# Comal County Environmental Health OSSF Inspection Sheet

## Permit of Authorization to Construct an On-Site Sewage Facility Permit Valid For One Year From Date Issued

Permit Number: 116824  
Issued This Date: 11/22/2023  
This permit is hereby given to: Daniel & Nell Ulrich

1442 RIVIERA DR  
CANYON LAKE, TX 78133

**SITE PLAN & OSSF DESIGN:**

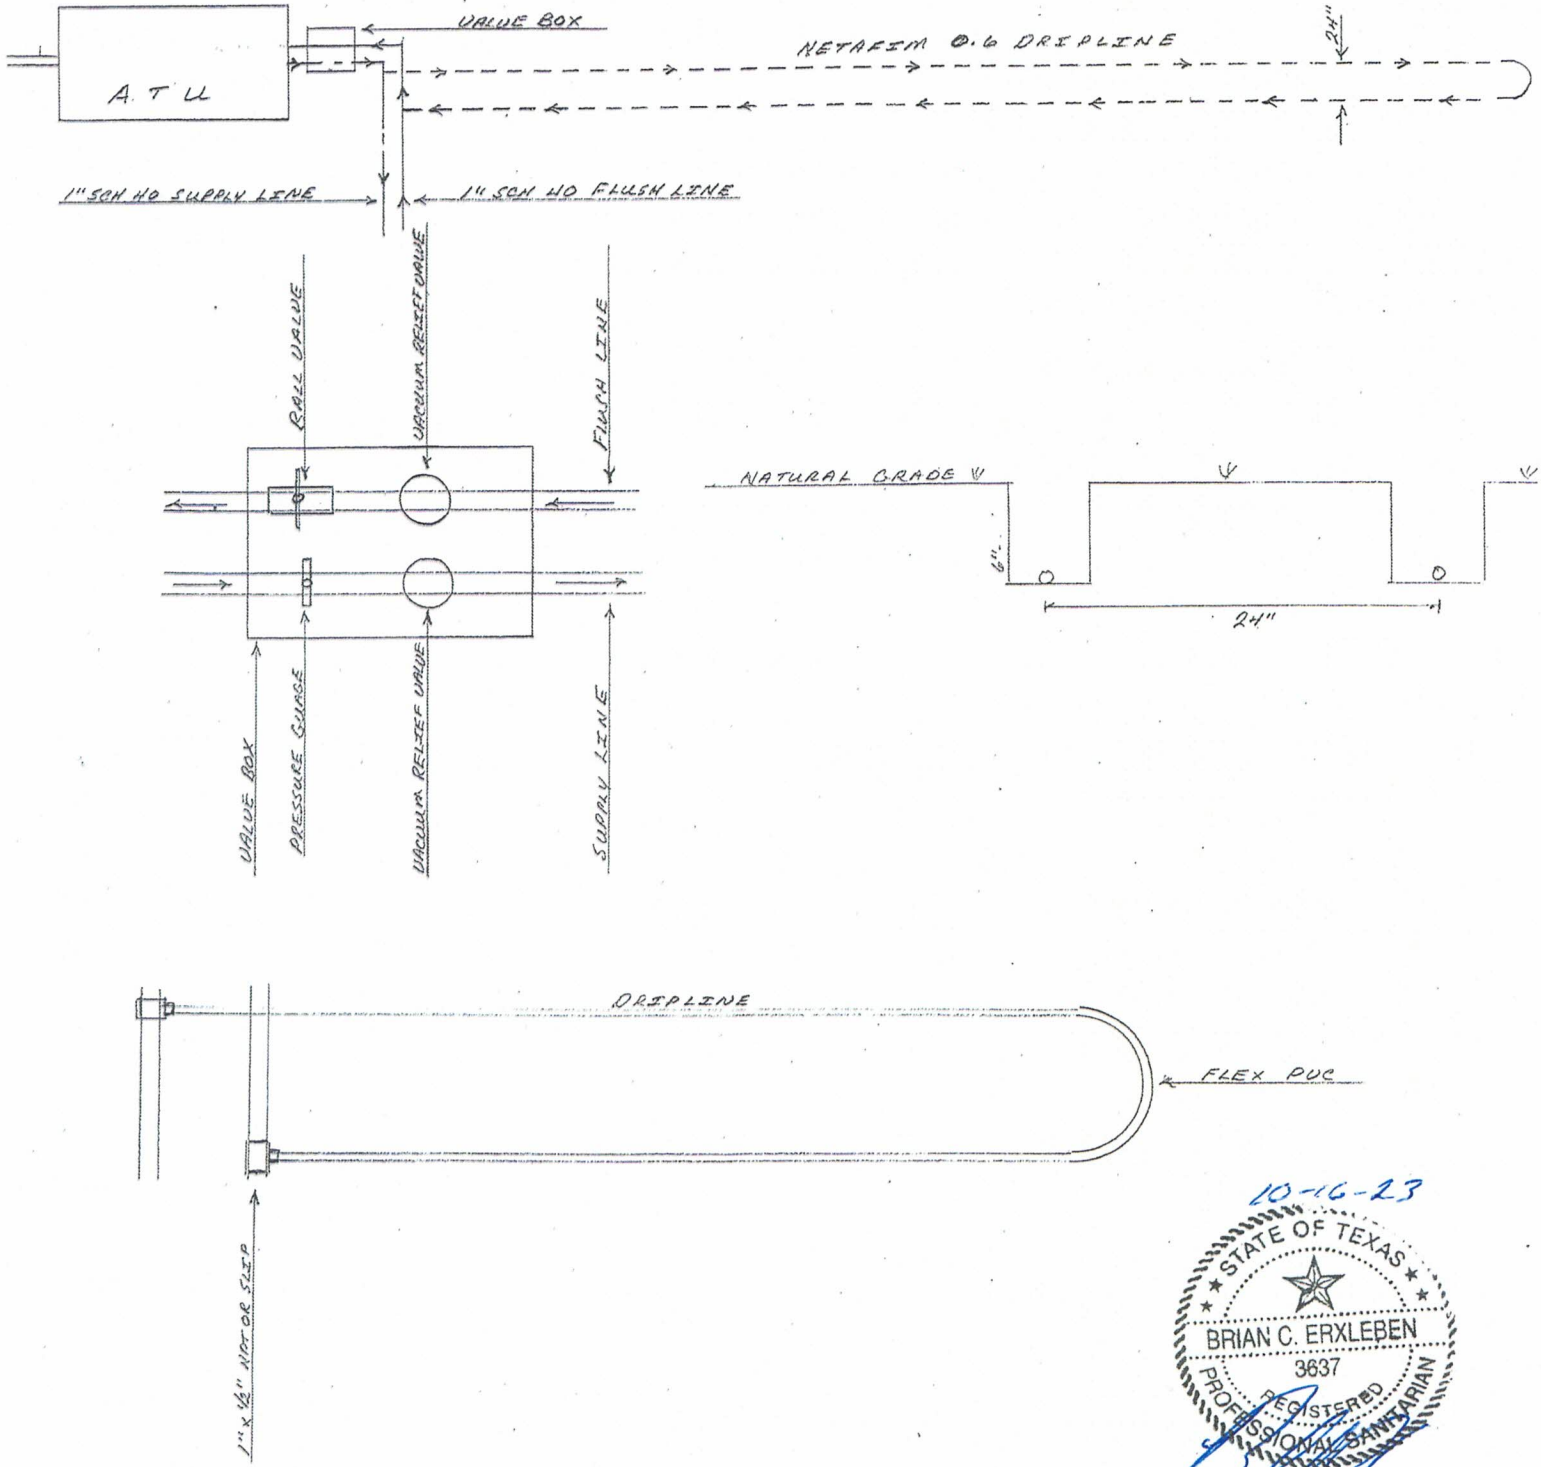
The address for this property is shown as 1430 Riviera Dr. Our addressing team says the property should be 1442 Riviera Dr. Contact our addressing team with any questions and update the paperwork accordingly.

The address listed on this permit is incorrect. Based on the site plan included, the valid address should be 1442 RIVERA DR.

DANIEL & NELL ULRICH 1442 RIVIERA DRIVE CANYON LAKE, TEXAS 78133	
BRIAN C. ERXLEBEN, R.S. 562 S. HWY 123 BYPASS #128 SEGUIN, TEXAS 78155 (830) 660-9133	DATE: 9-7-23  SCALE: 1" = 20'
